NUMBER: 18-011-13

Flash: MIL Illumination P050B and/or Rattle/Clatter Sound on Cold Start-up

This bulletin involves installing revised heater hoses, routing the purge solenoid wire harness, and installing revised Powertrain Control Module (PCM) software.

2011 - 2013 MK

Fig. 1 Purge Solenoid Wire Harness

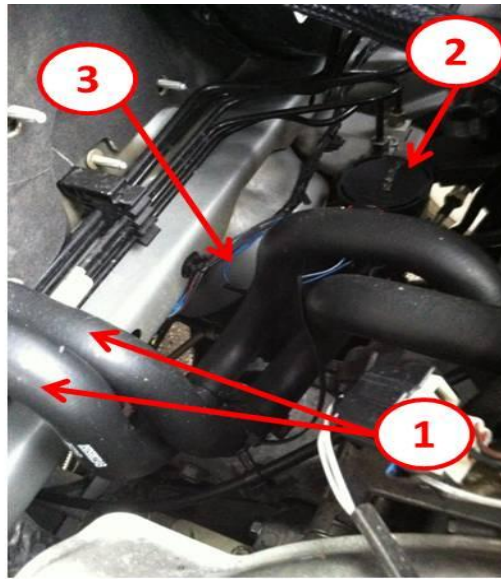
5. Without removing the pressure cap and with system not under pressure, turn draincock counterclockwise to open.
6. The coolant reserve bottle should empty first, then remove the pressure cap.
7. Allow cooling system to drain completely.
8. Remove both supply and return heater core hoses.
9. Install new heater core supply hose (p/n 05058822AB) and heater core return hose (p/n 05058823AB).
10. Install the right wheel inner splash shield.
11. Remove the engine cover.
12. To ensure that the purge solenoid wiring harness ([Fig. 1](#)) does not come in contact with the heater hoses, the wire harness will require a slight modification.

13. Loosely pull the purge solenoid wire harness straight and create a bend in the harness approximately 10mm (0.40 in. or 3/8 - 7/16 in.) away from the harness retaining clip edge. This bend will also create a natural bend after the current spot tape on the harness. Then, apply 3 - 4 wraps of electrical tape securing the bend to the harness as shown in (Fig. 2).
